Rezoning Application:

MM 21-1108

Hillsborough
County Florida

6.04.02B Administrative Variance Request from 6.04.04L Substandard Roadway Criteria

2.5 Proposed Site Plan (partial provided below for size and orientation purposes. See Section 8.0 for full site plan)

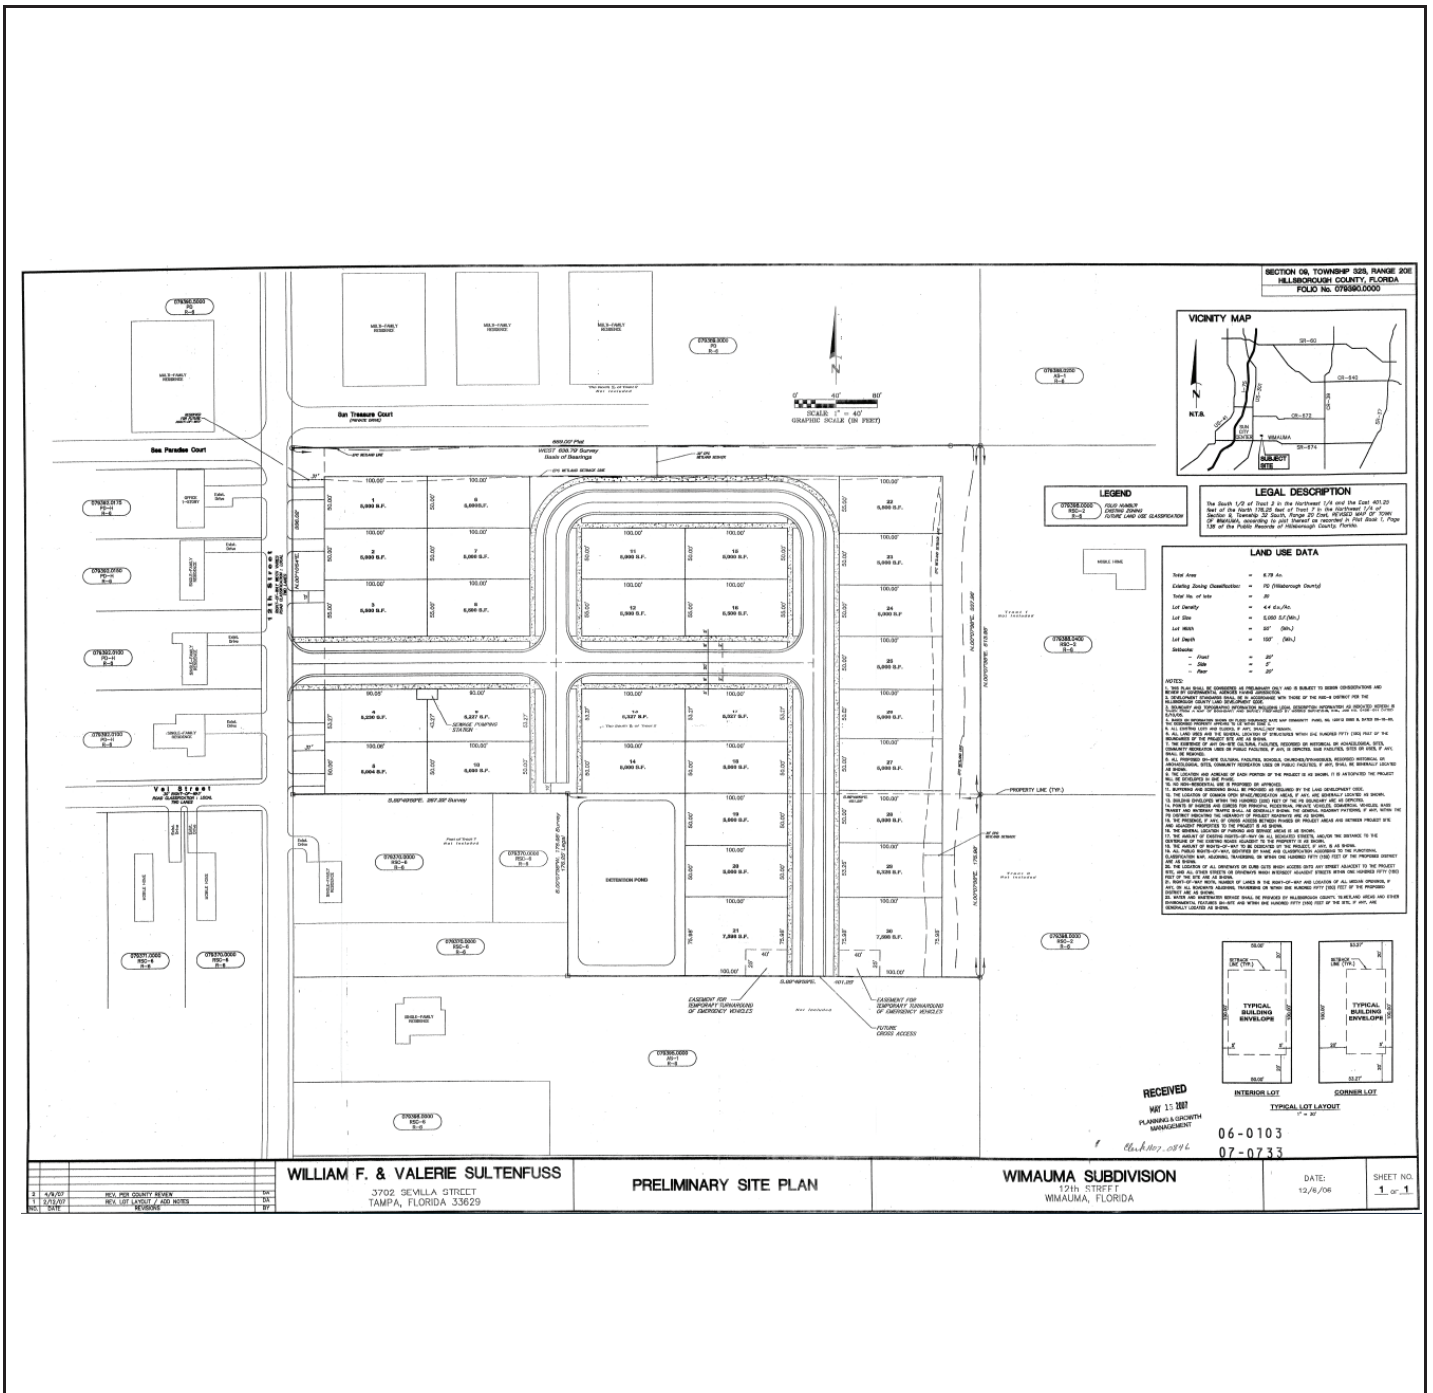
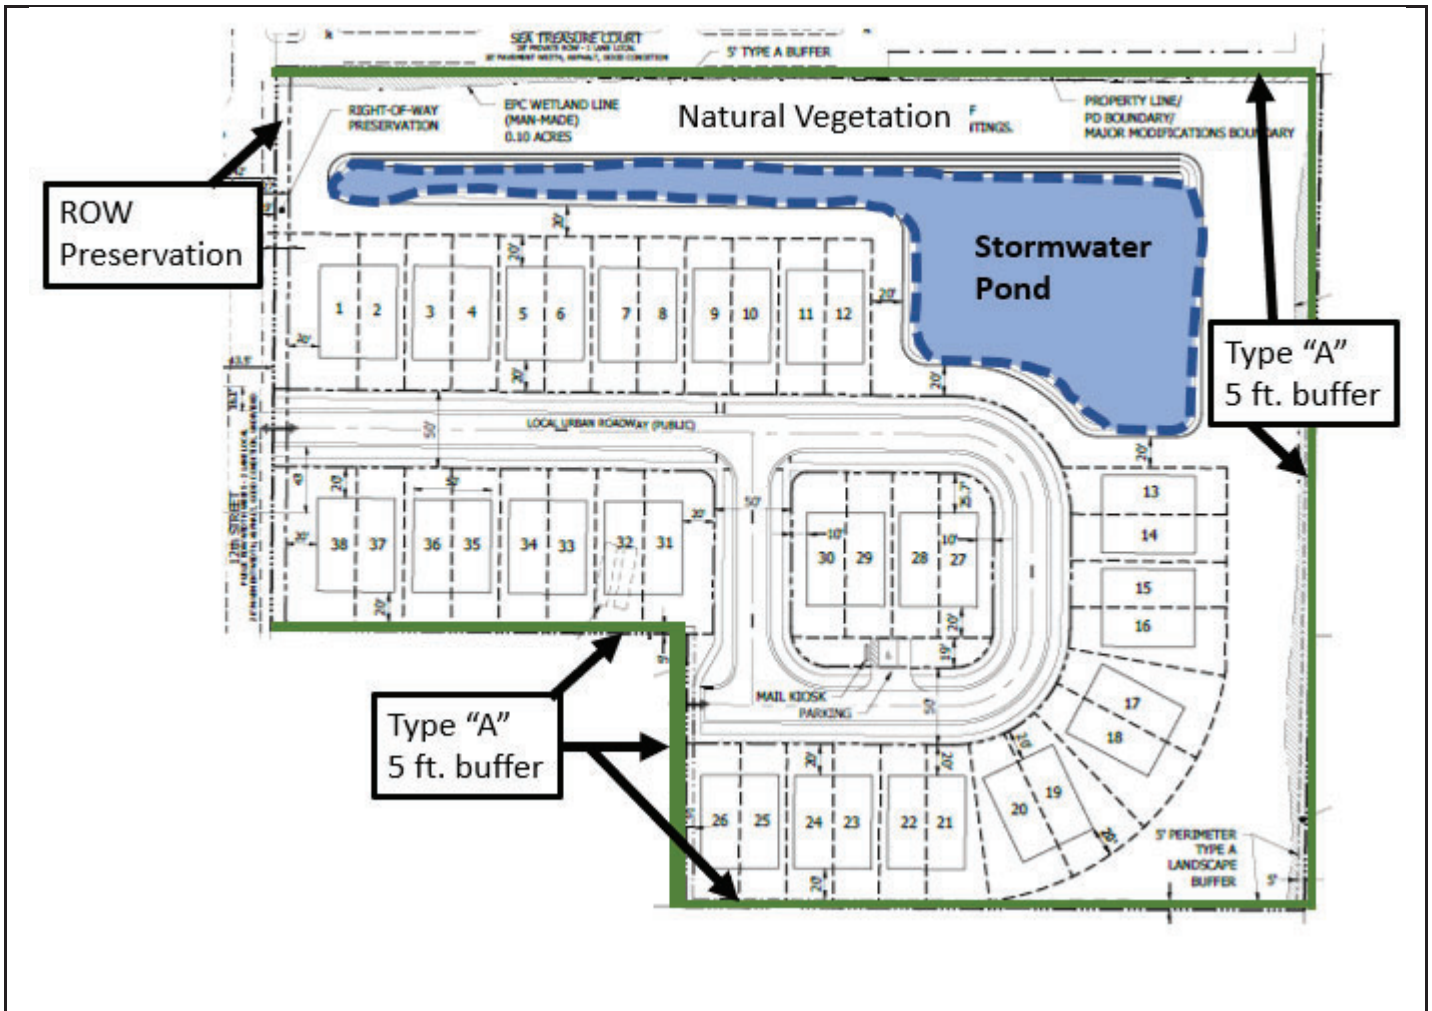
Lots 27 and 30 have three sides facing the street. The applicant proposes to provide 20-foot yards to the north and south, and 10-foot yards to the east of lot 27 and west of lot 30 in consideration of these site constraints, as shown on the site plan. The site plan shows a 5 ft. buffer / Type "A" landscaping adjacent to the property east and southern property boundaries. While not required, the applicant is also proposing a 5 ft. buffer / Type "A" landscaping on the north side of the PD boundary. The applicant requests no Variations for Site Design.

There are wetlands present on the subject property. The Environmental Protection Commission (EPC) Wetlands Division has reviewed the proposed rezoning and has determined a resubmittal is not necessary for the site plan's current configuration. If the site plan changes, EPC staff will need to review the zoning again.

Prior to PD site plan certification, the applicant shall revise the PD site plan to:

- Add a note to the site plan that states “Sidewalks shall be provided in accordance with the Hillsborough County LDC.”

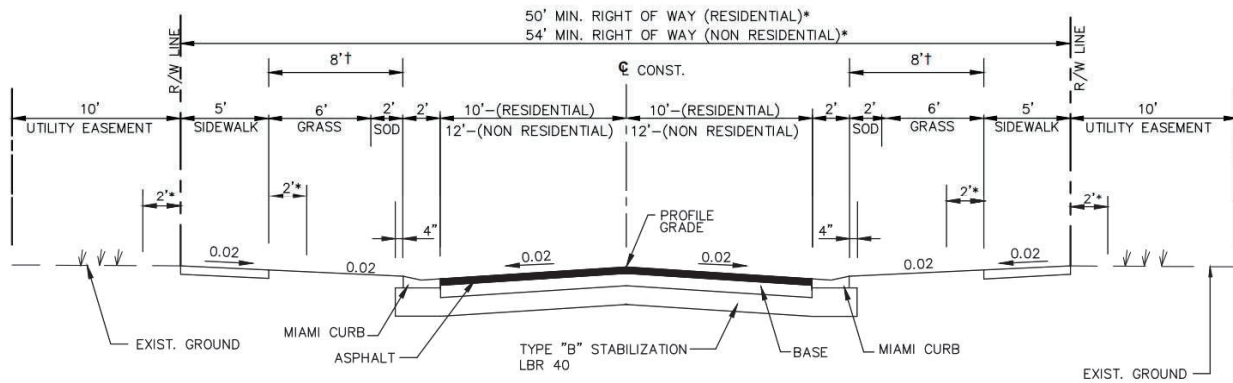
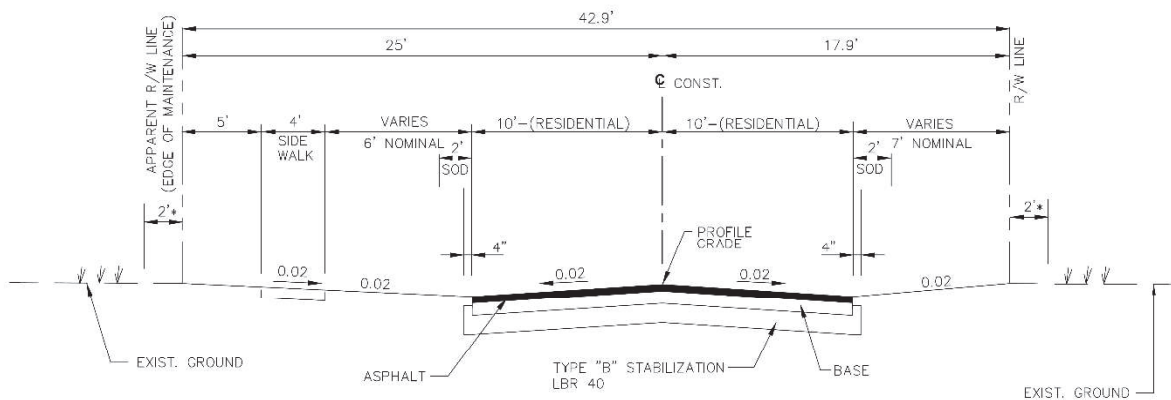
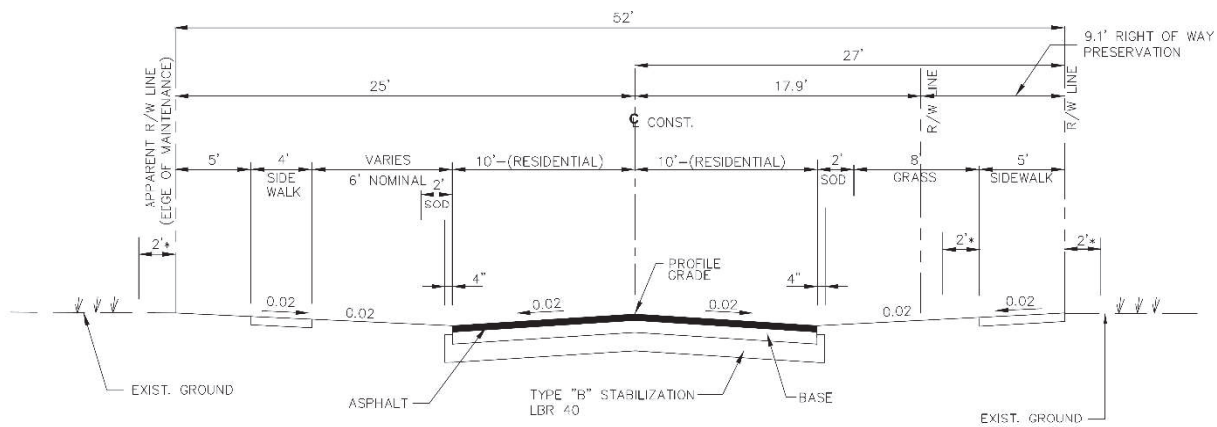
Hillsborough County Transportation Technical Manual Drawing Number TS-3 (See Figure 1) specifies a roadway cross section with 10-foot travel lanes, 2-foot Miami Curb, 8 feet of sod/grass, and 5-foot sidewalks. Currently, 12th Street has two 10-foot travel lanes and a sidewalk on the west side of the roadway (See Figure 2). There is no curb and drainage is unencumbered into the unpaved area adjacent to the roadway.

With this project, the developer intends to dedicate approximately 9 feet of right of way to Hillsborough County to provide half of the required total right of way from the centerline of the road to match TS-3 (ROW width for dedication was based upon the wider 54' total ROW width for commercial streets). The developer will also construct a new sidewalk at this new right of way line. In doing so, the developer will bring the eastern half of 12th St across the project's frontage in substantial conformance with TS-3 (See Figure 3).

6.04.02B Administrative Variance Request from 6.04.07 – Table: Minimum Spacing

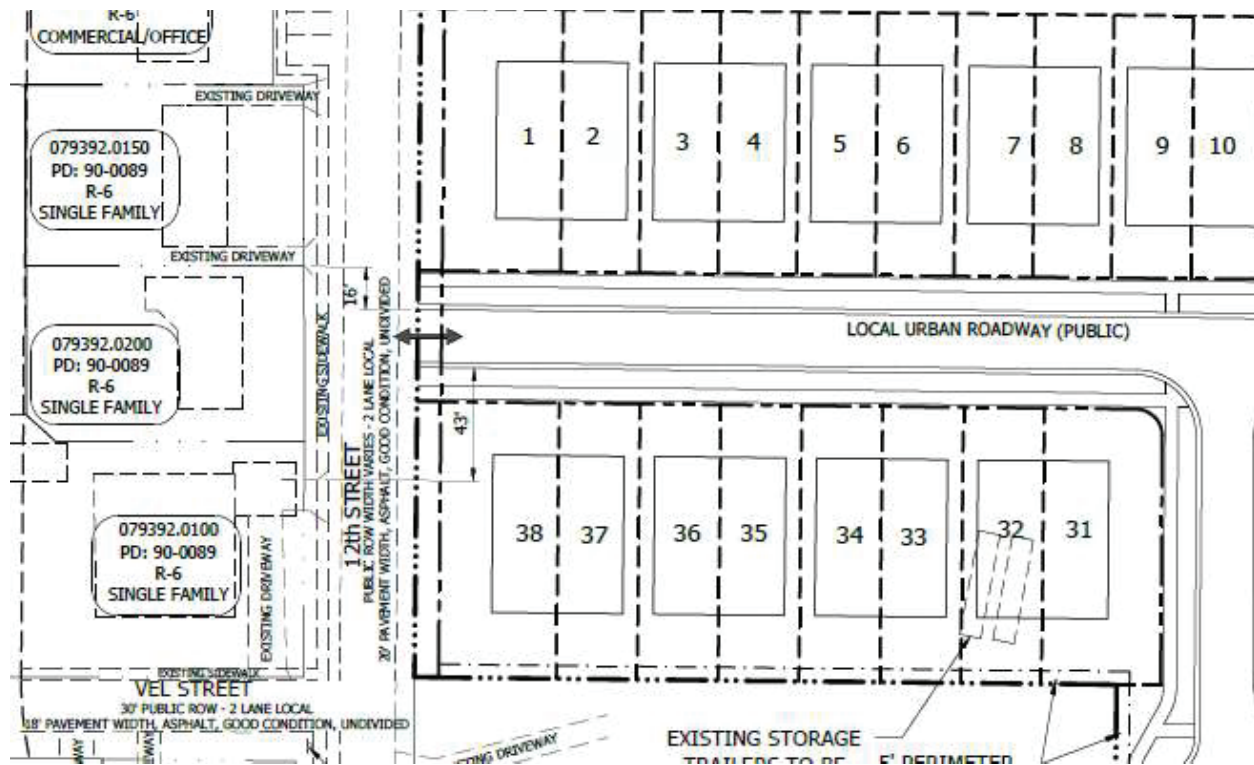
Section 6.04.07 of the Hillsborough County Land Development Code (LDC) specifies minimum connection spacing between access connections. 12th Street is classified as a Class 7 roadway, and the proposed driveway will be a Type II driveway. The LDC specifies a 50 ft minimum connection spacing for Type II driveways on Class 7 roadways. The proposed site design would provide a connection spacing of 43 ft from the nearest southern driveway and 16 ft from the nearest northern driveway; we are requesting a reduction in access connection spacing of 7 ft and 34 ft, respectively, from the two driveways. See Figure 1 for an exhibit of the proposed entrance and connection spacing as taken from the proposed site plan.
